Technical Service Information

THM 4L60-E

PREMATURE 3-4 CLUTCH FAILURE (LOAD RELEASE)

Figure 1

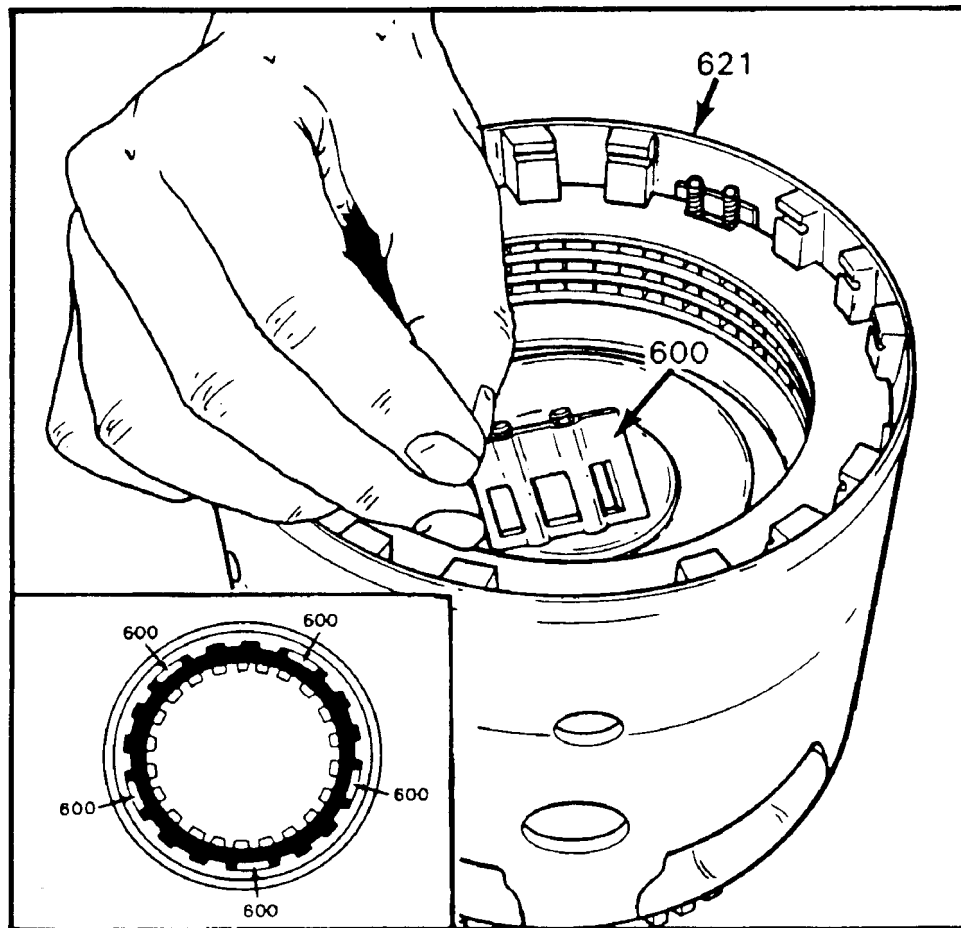
COMPLAINT: Premature failure of the 3-4 clutch pack and may happen in as 5000 miles. The vehicle may also exhibit a very soft 2-3 shift little

CAUSE: The cause may be, not enough clamping force for the 3-4 clutch due to the 3-4 load release spring assemblies. pack

Remove and discard the five 3-4 load release spring assemblies in the input housing and located between the steel plates and the input housing, as shown in Figure 1.
